Our Job Number: 230203
5 August 2023

Council Ref: DA2023/0995

RE: DEVELOPMENT APPLICATION 52-54 BRIGHTON STREET, FRESHWATER NSW STORMWATER MANAGEMENT RESPONSE

Figure 1.0 – Rainwater Tank Reuse Demands

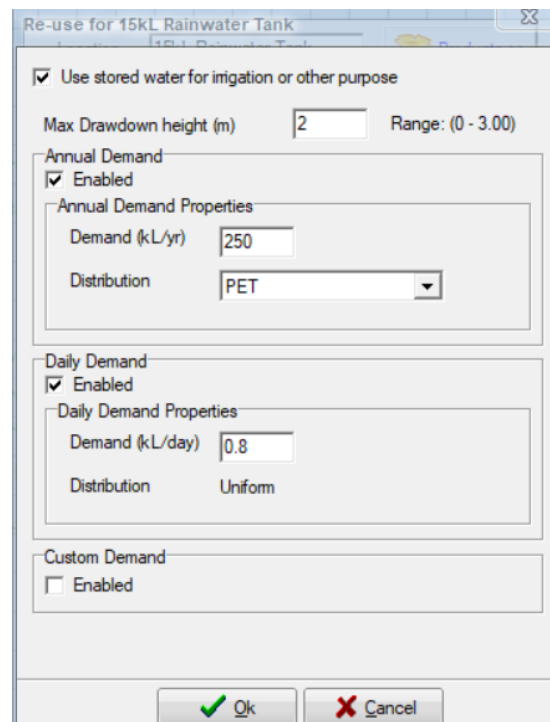
Details of the rainwater tanks water demands used in the water quality model is required.

4. **SQID5:** A rainwater harvesting tank system to treat 659m² of roof runoff. The proposed volume has been increased from 10,000L to 15,000L. This is to be provided within a series of slimline rainwater tanks. The overflow is directed to SQID1. It should be noted that the roofwater is also proposed to be treated via a first flush system which is not reflected in the MUSIC model.

- a. An irrigation reuse rate of 0.4kL/m²/yr and 0.1kL/apartment/day toilet reuse has been applied (see Figure 1.0 below).

Figure 2.0 – Stormwater Management Strategy and Stormwater Treatment Chain MUSIC Model Results

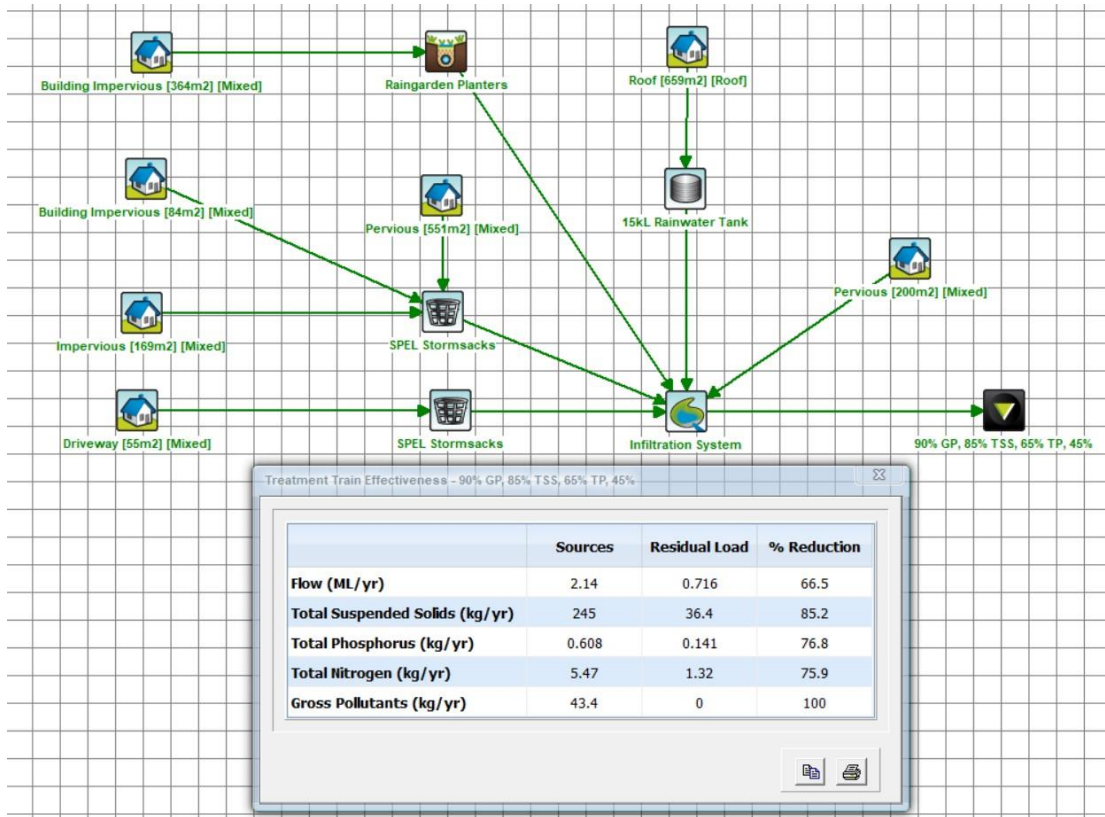
Council does not support the use of proprietary devices for pollutant removal if they do not achieve natural water cycle processes such as infiltration, evaporation or transpiration. Stormwater Cartridges as the sole water quality measure are not sufficient as they do not fulfill Councils WSUD objectives.

Consider incorporating WSUD elements onsite and investigate opportunities to place vegetated water quality system. Suggestions for WSUD optimisation includes, but is not limited to, incorporation of vegetated swale, tree pits, filter planter box, rain gardens or green roofs into design.

The applicant is to submit a stormwater management strategy and plan based on a stormwater treatment chain.

Please refer to Figures 2.0 and 3.0 indicating the updated MUSIC model summary reflecting the amended stormwater management strategy and stormwater treatment chain. The proposed stormwater treatment chain meets the Council target removal requirements. A copy of the amended MUSIC model has been provided with this letter.
